To: Mayor and Council
RE: Staff Review –Lot 1, Village West
Commercial Corridor Overlay Hwy85/Hwy 16
Number of Variances requested: 6

The applicant has submitted a variance application for relief from Commercial Corridor Overlay standards.

LOT 1 @ VILLAGE WEST

CONCEPT SITE PLAN

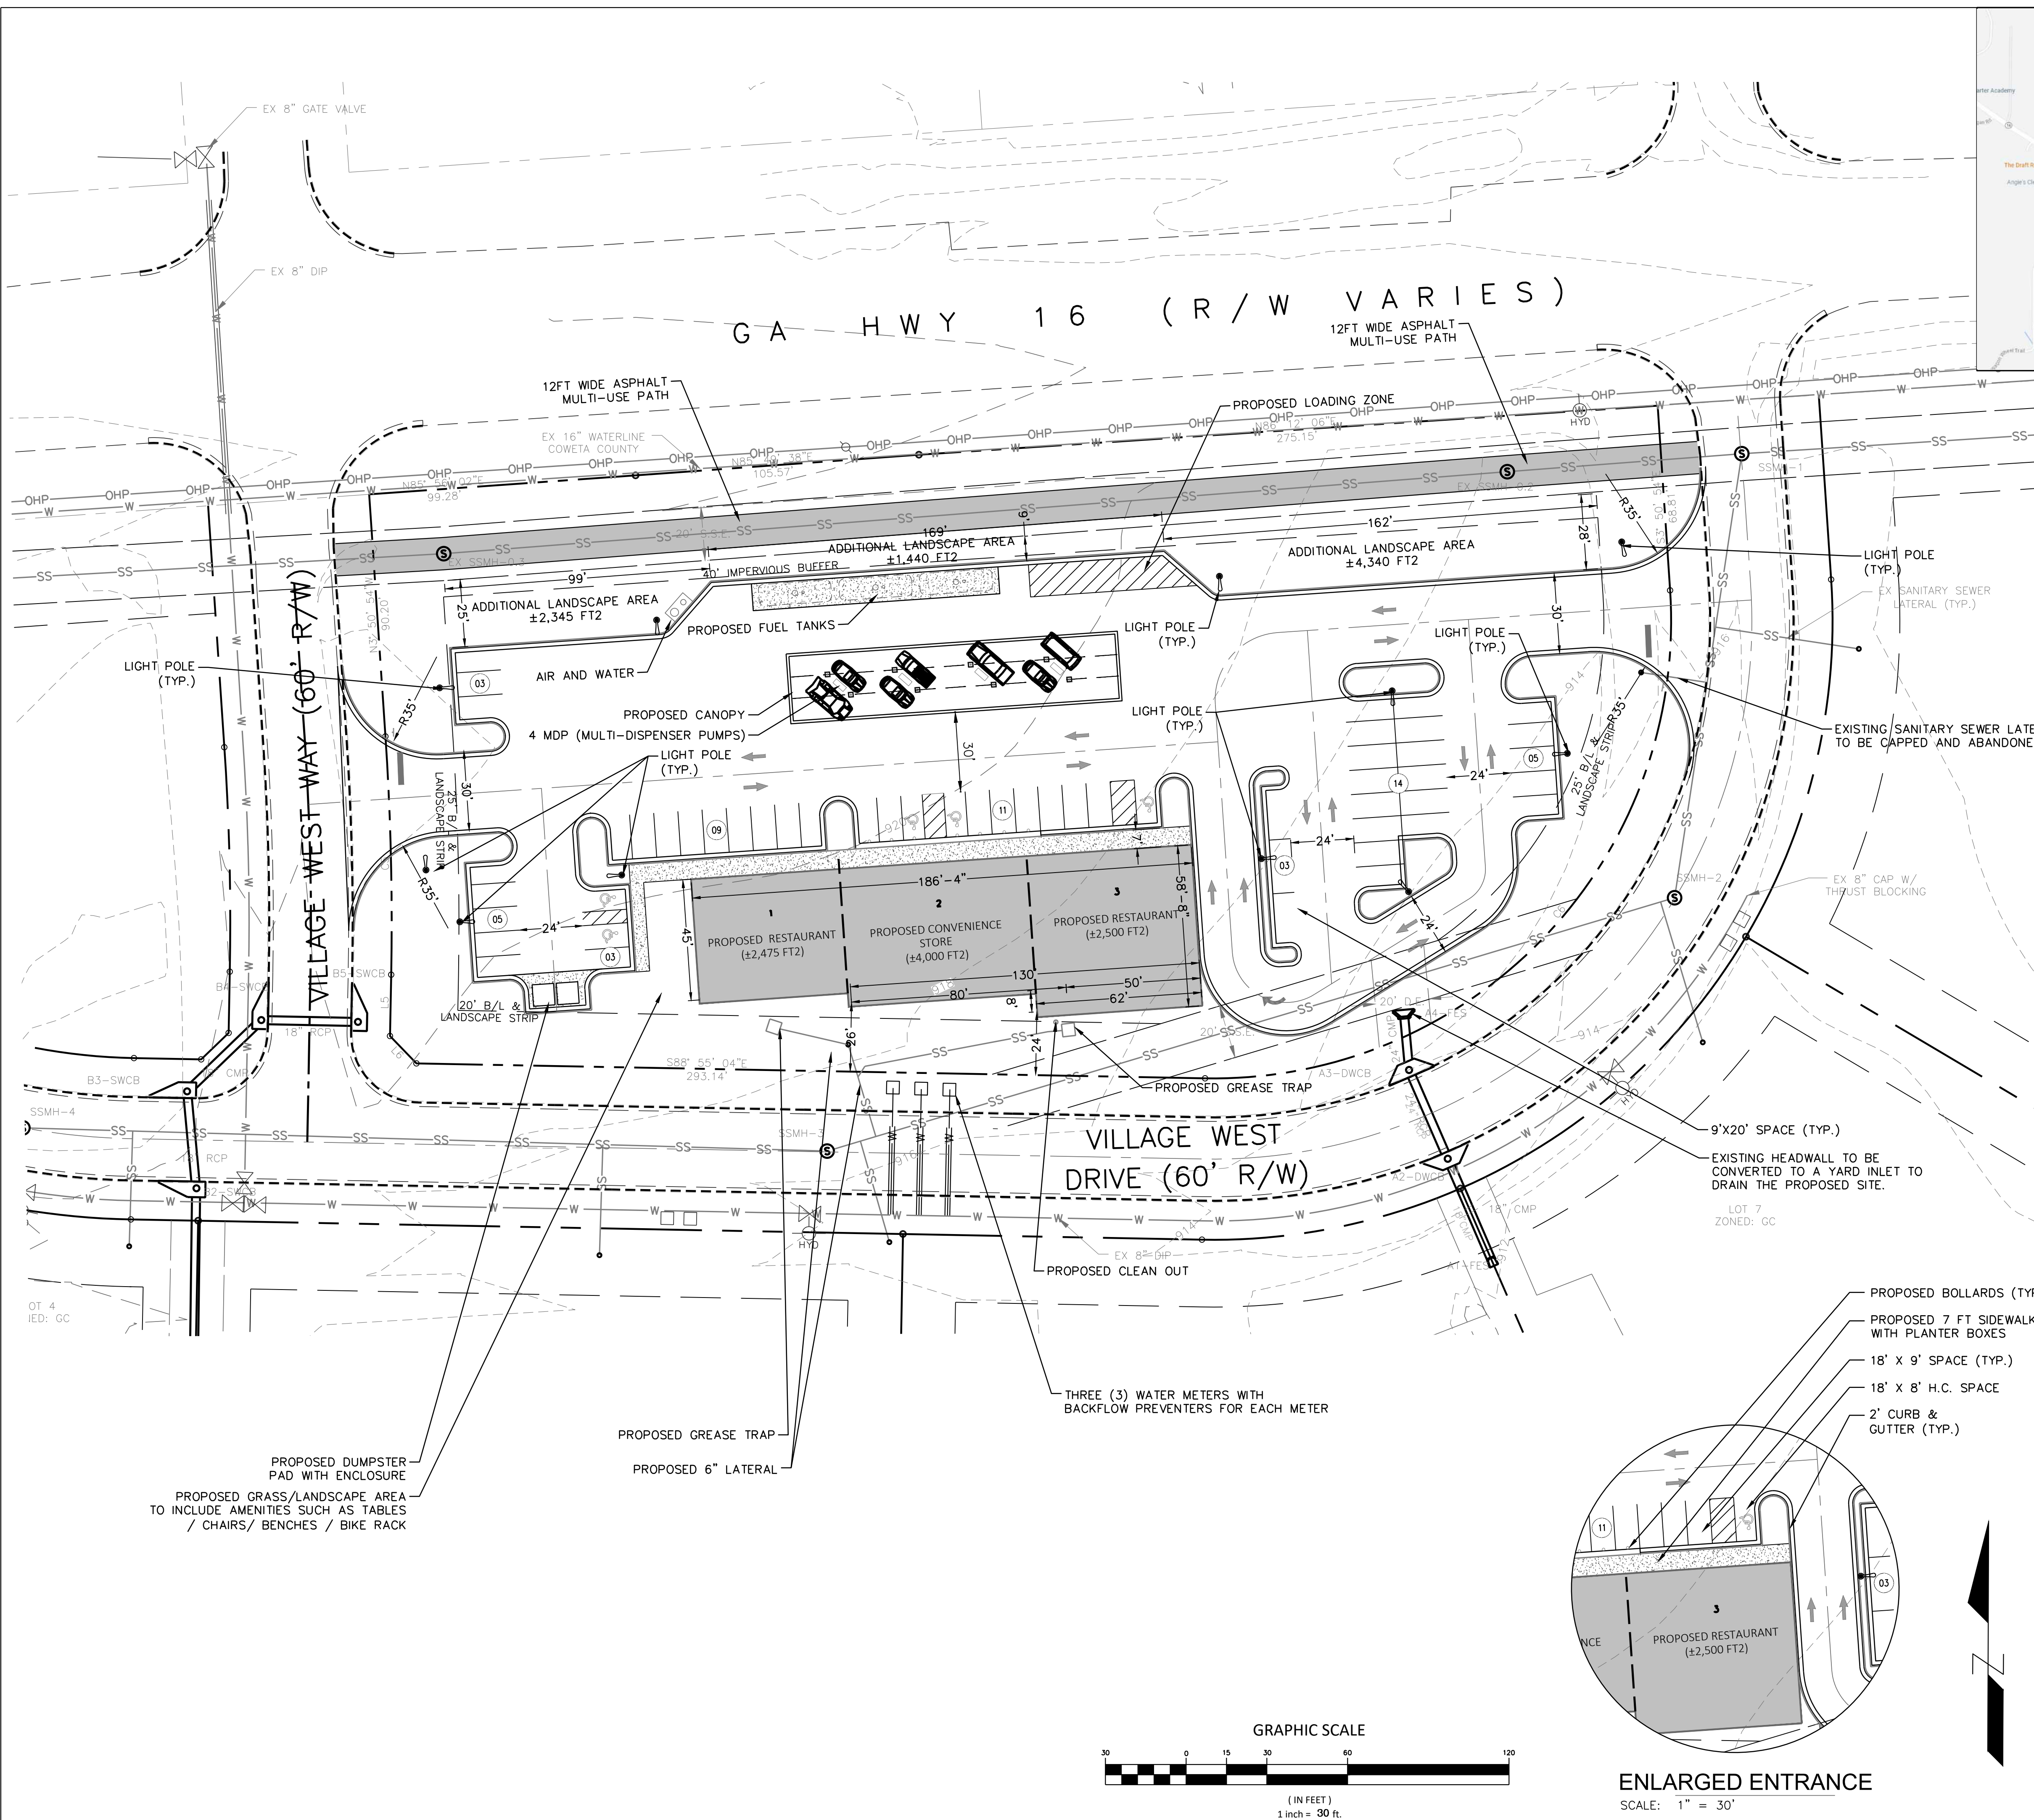
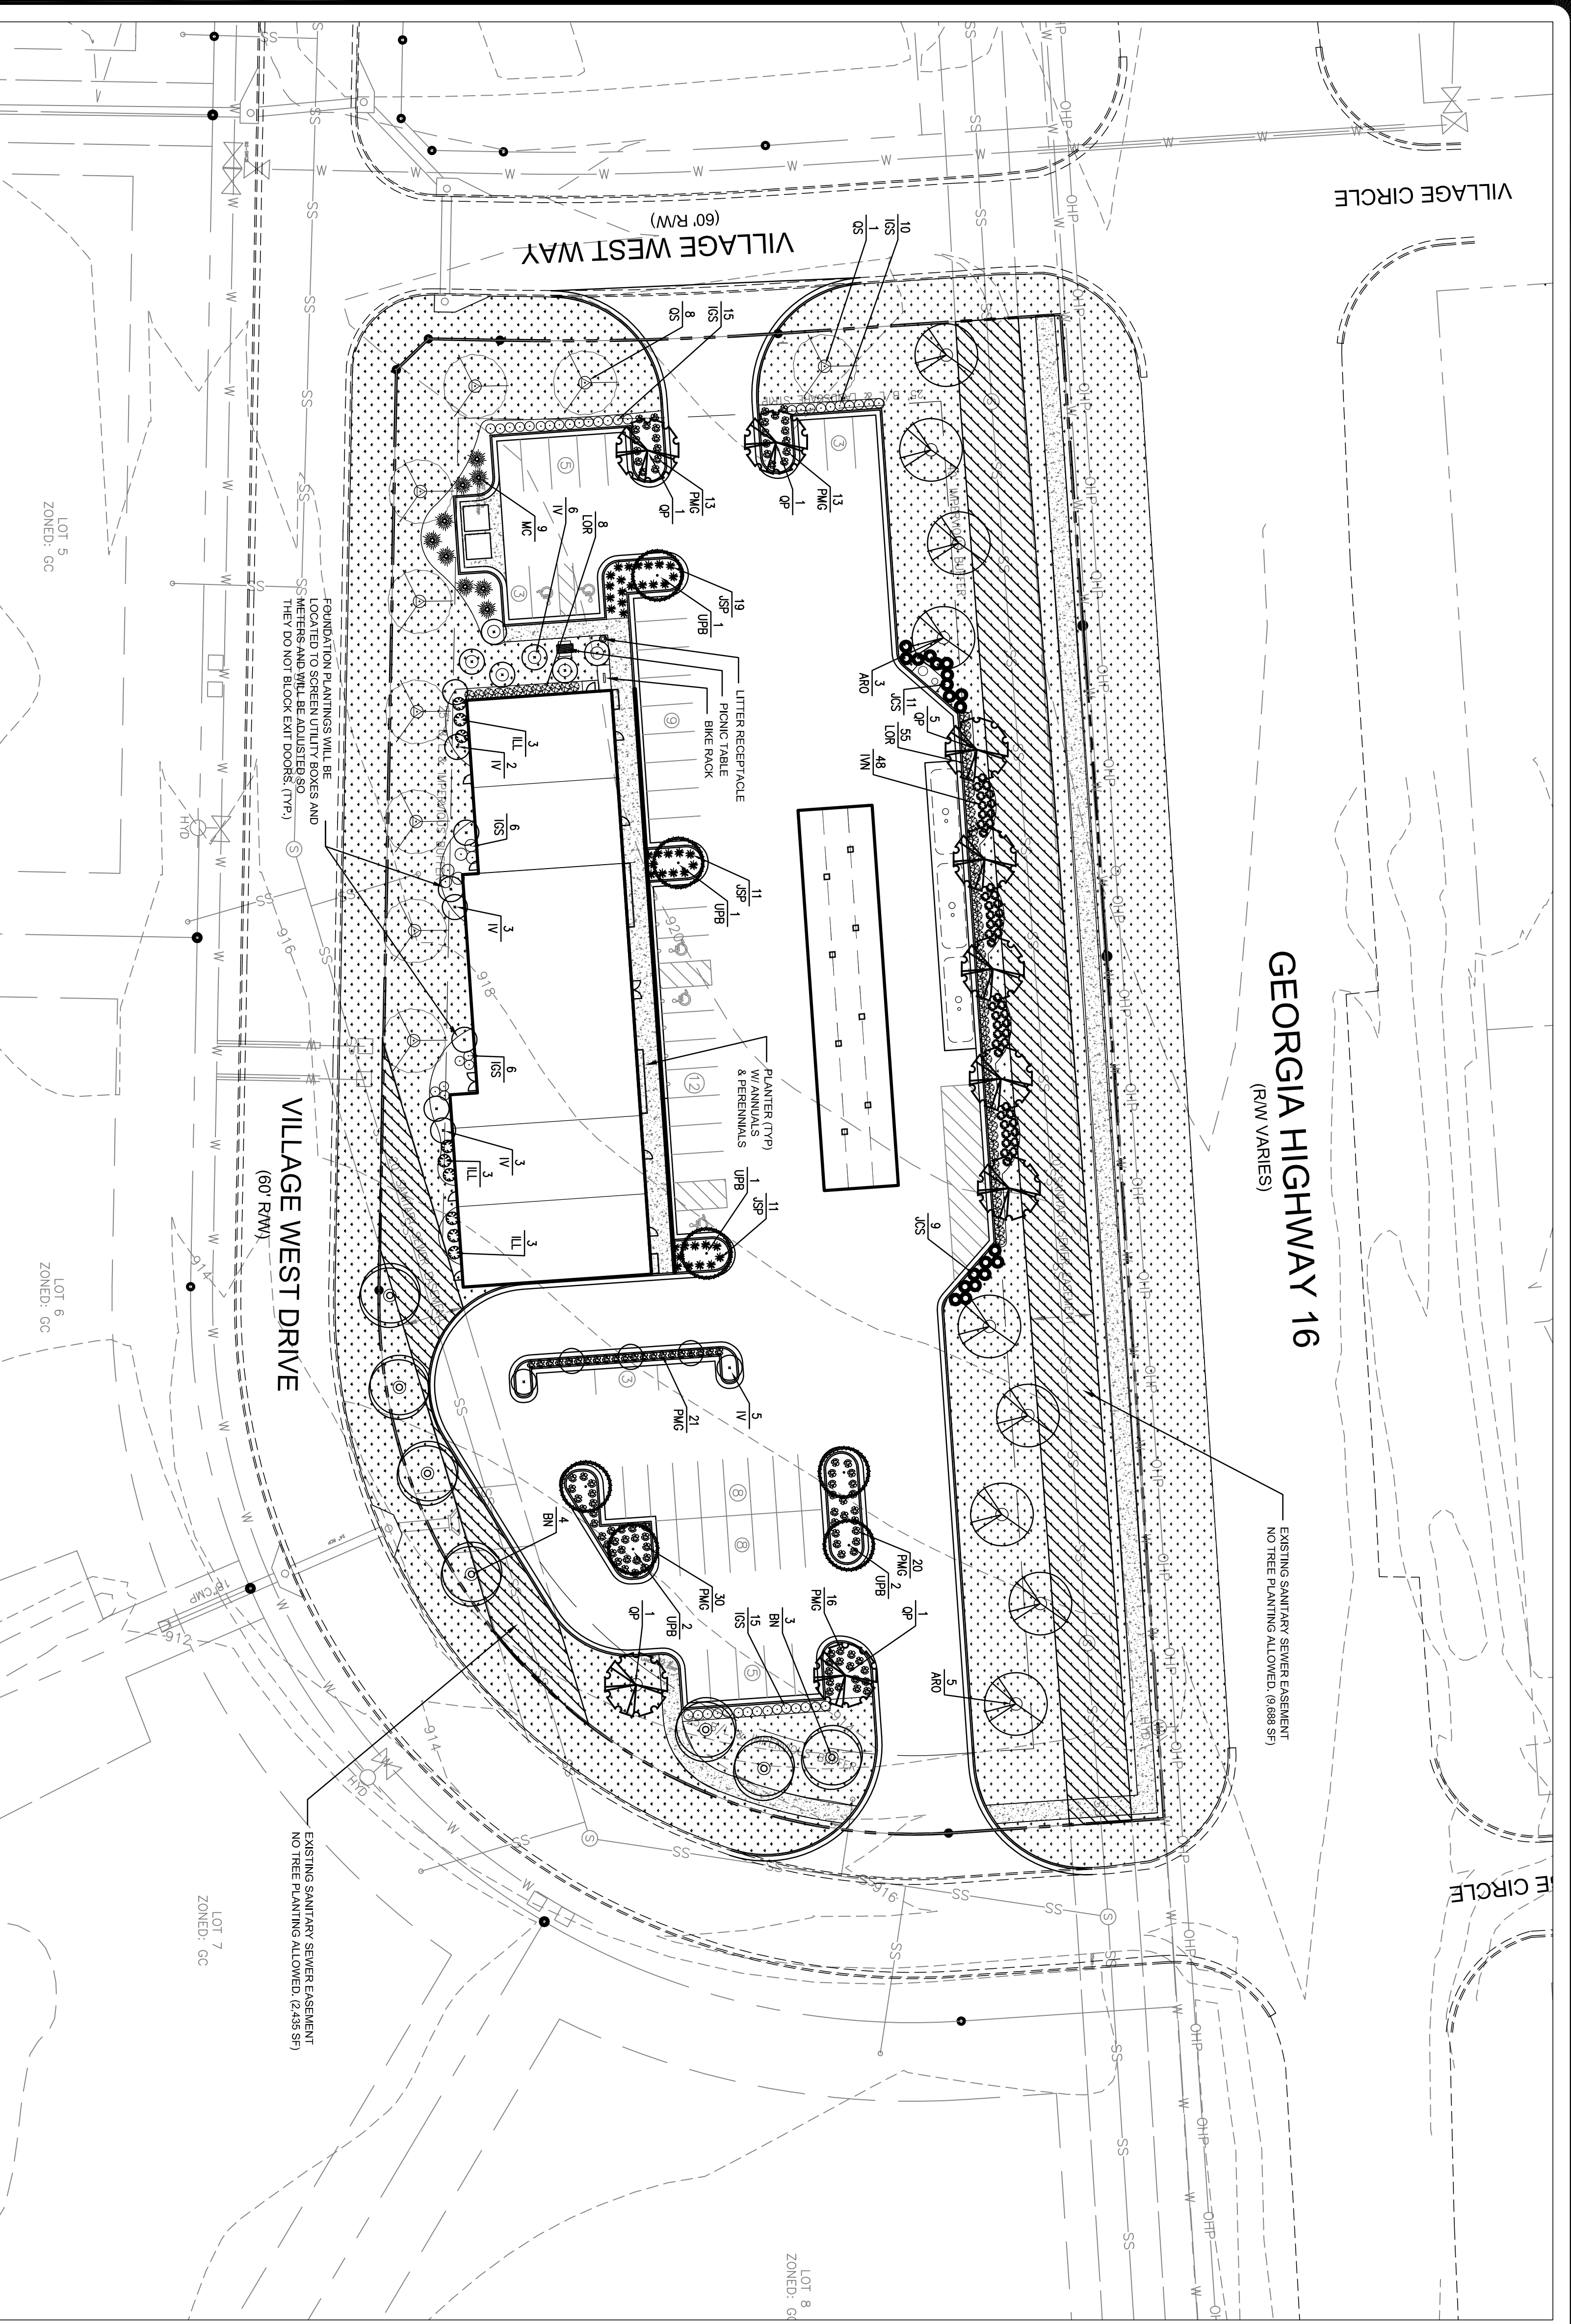
Sec. 74-186 (e) - location of parking – Off-street parking shall be uniformly distributed with 25% in the front (between building and right of way), 50% percent on sides, and remaining in the rear of the building.

- Consider approval of the variance on the parking layout as presented in the Site Plan. Site layout including driveway locations and parking were adjusted during the conditional use application at the request of Council. The Planning Commission reviewed the site plan on 6.20.23 and recommended approval subject to variances being approved by Mayor and Council.

Sec. 74-196 (a) – Pedestrian Improvements – development shall provide sidewalks with a minimum width of six (6) feet along all frontages of the lot that abut a public street.

- The applicant would be required to install 1,410 linear feet at 6 foot wide sidewalk under the requirements of the ordinance. Using the average of GADOT item mean summaries from previous years, the installed cost is estimated to be at least \$60 per square yard or approximately \$56,400.

- Require sidewalk along all public road frontages, per the ordinance, or
- Allow applicant to construct a 12 foot wide multiuse trail along the primary frontage (Hwy 16) and waive remaining sidewalk along Village West internal roads, or
- Allow applicant to pay a fee in lieu for all required sidewalk toward the connectivity goals listed in Comp Plan.

FRONT ELEVATION
 1/8"=1'-0"

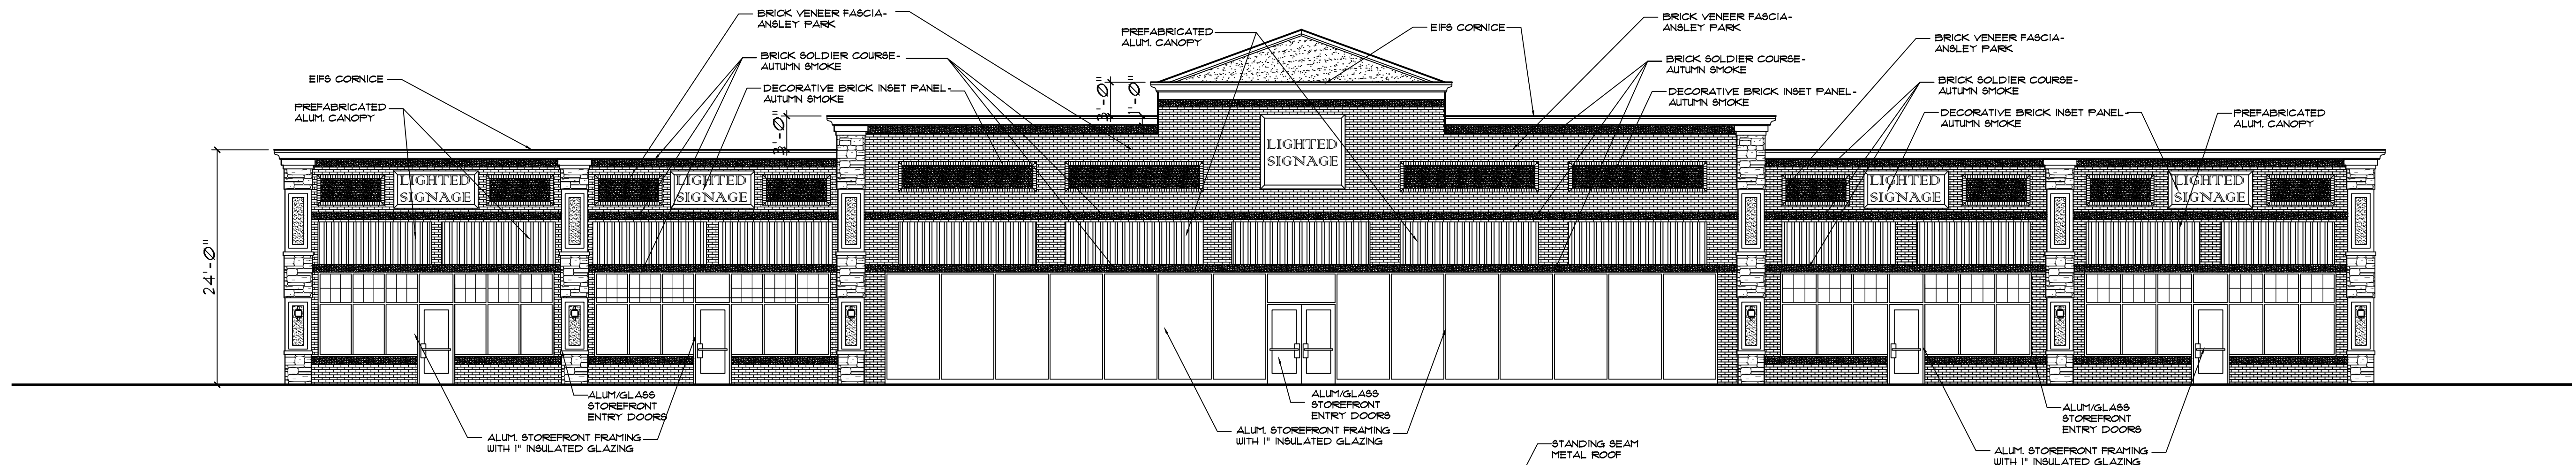
- Consider approval of the variance to allow a blank windowless wall on the rear elevation with false windows as presented on the updated elevations.
- Consider approval of the variance to allow the storefront elevation to be 47 percent windows on the primary façade and 3 percent windows on the secondary facades, as presented on the updated elevations.
